World Forum for Harmonization of Vehicle Regulations

Proposal for Supplement 7 to the 08 series of amendments to UN Regulation No. 48 (Installation of Lighting and Light- Signalling Devices)

Submitted by the Working Party on Lighting and Light-Signalling*

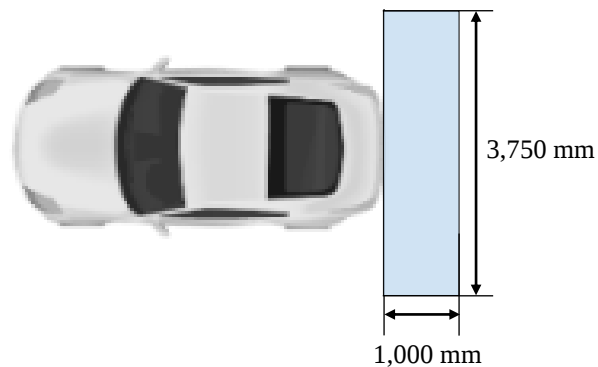
6.27.5. Projection area

6.27.5.1. The lateral distance from the outer edge of the projection with respect to the longitudinal plane of the vehicle shall not be more than 1,875 mm.

The longitudinal distance from the farthest edge of the projection shall not be more than 3,000 mm from the backward extreme outer edge of the vehicle (see figure below).
